MEADOWBROOK CROSSING

CIVIL CONSTRUCTION DRAWINGS

EL PASO COUNTY, COLORADO

MEADOWBROOK CROSSING
COVER SHEET
EL PASO COUNTY, COLORADO

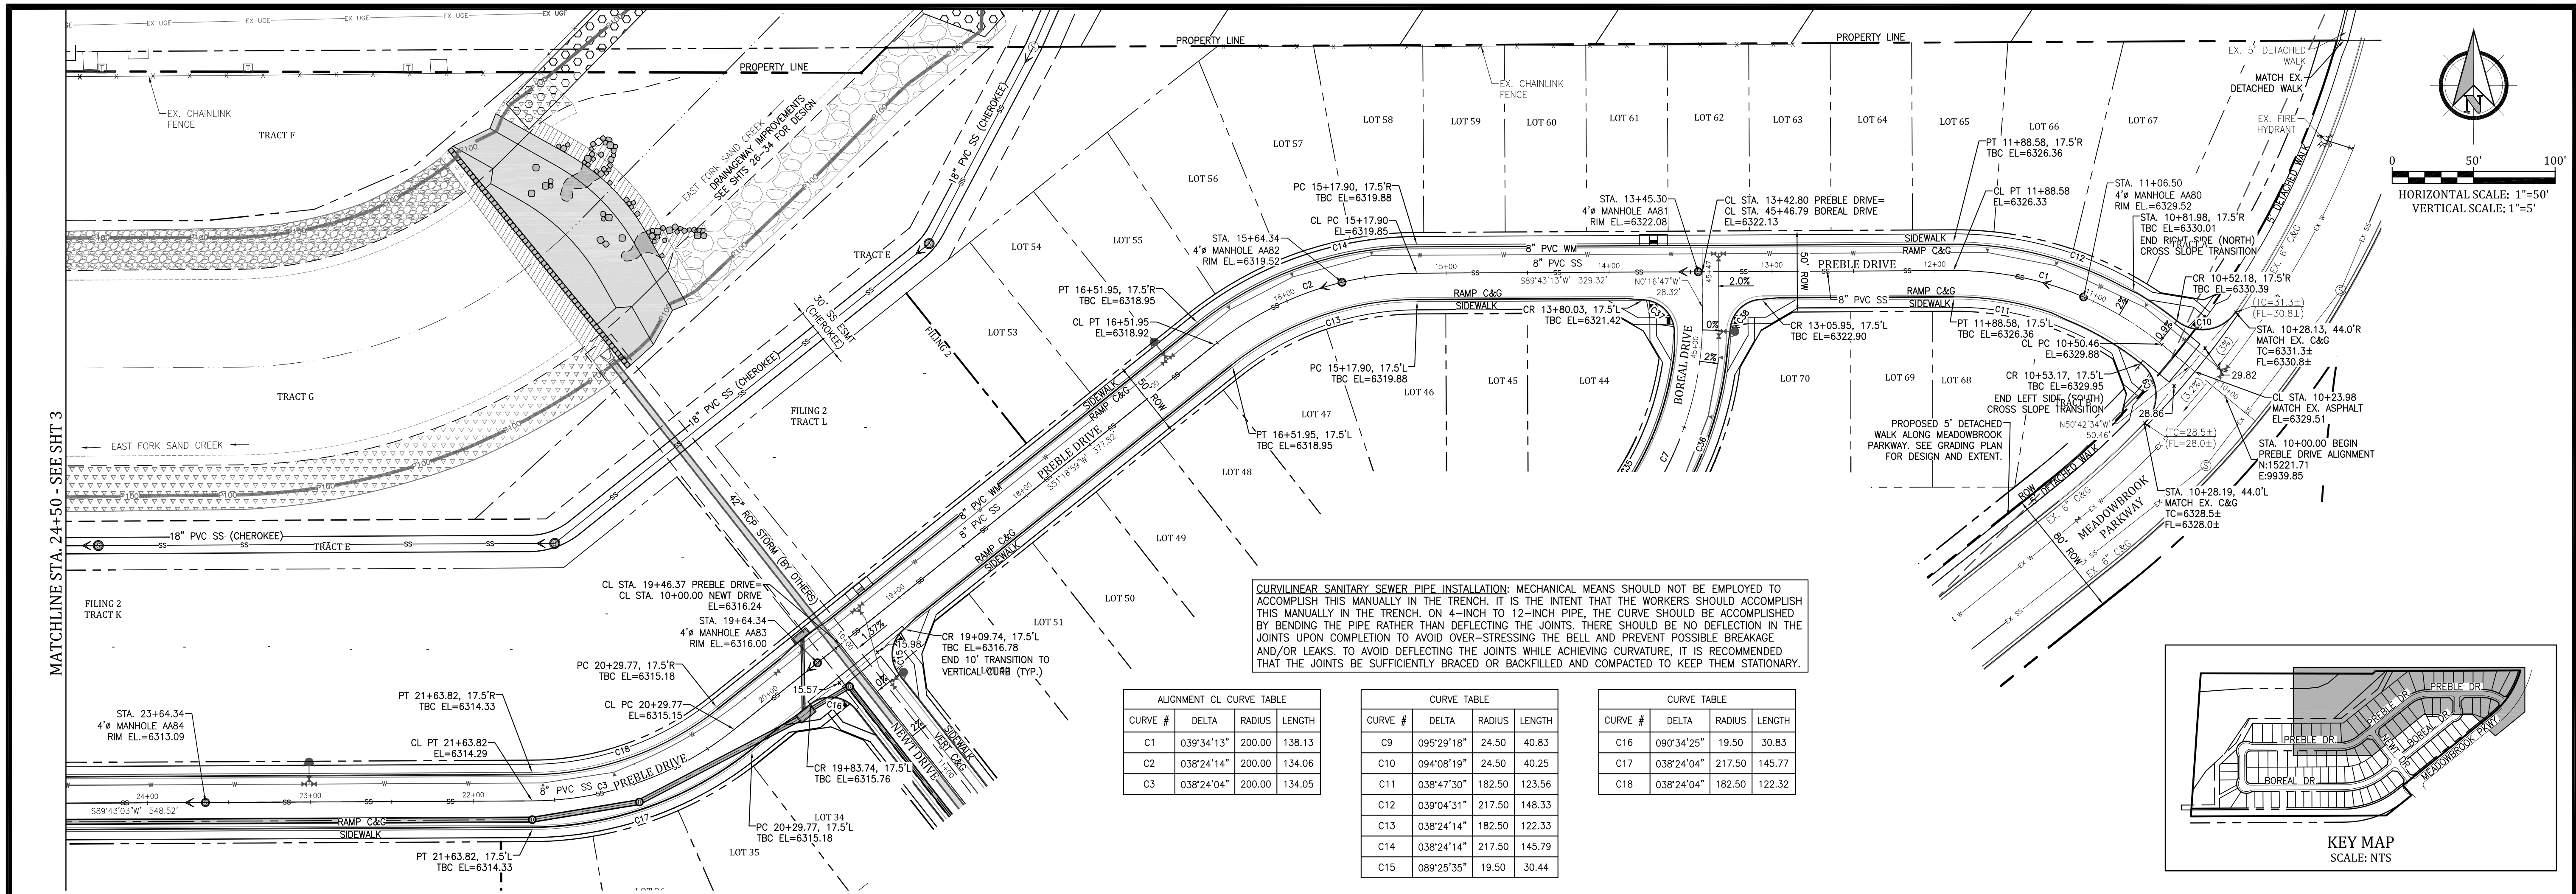
Rename to Meadowbrook Crossing Filing No. 1

Add as a 3rd paragraph:
In accordance with ECM Section 1.12, these construction documents will be valid for construction for a period of 2 years from the date signed by the El Paso County Engineer. If construction has not started within those 2 years, the plans will need to be resubmitted for approval, including payment of review fees at the Planning and Community Development Directors discretion.

Add: PCD Project No. SF-17-002
